**SUBJECT:** RE: [Docket No. 72–1050; NRC–2016–0231] Environmental Impact Statement for Interim Storage Partners LLC’s License Application for a Consolidated Interim Storage Facility for Spent Nuclear Fuel in Andrews County, Texas, Final Report, NUREG-2239, July 2021

### Comments on NUREG-2239 — Docket NRC-2016-0231

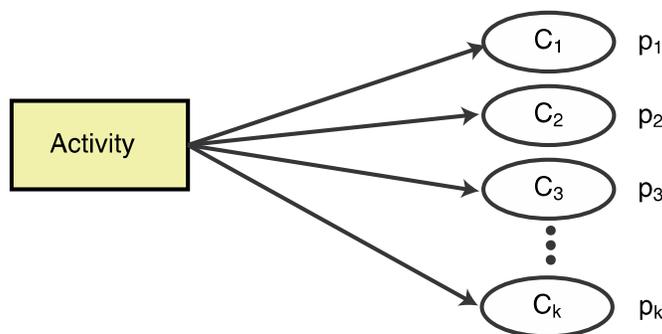
Risk is a bi-dimensional expression of the relationship between (1) the probability that a given event will occur and (2) the consequence(s) of that event. It is generally represented as a spectrum of outcomes as follows:

Therefore, the NRC practice of computing a “dose risk” as the *product* of a radiological dose and an event probability is unfounded and grossly misrepresents the risk picture of the activities under evaluation, in violation of (i) 10 CFR 51.70(b) in that the necessary environmental analyses have not been made and (ii) 10 CFR 51.71 in that it does not comply with national or
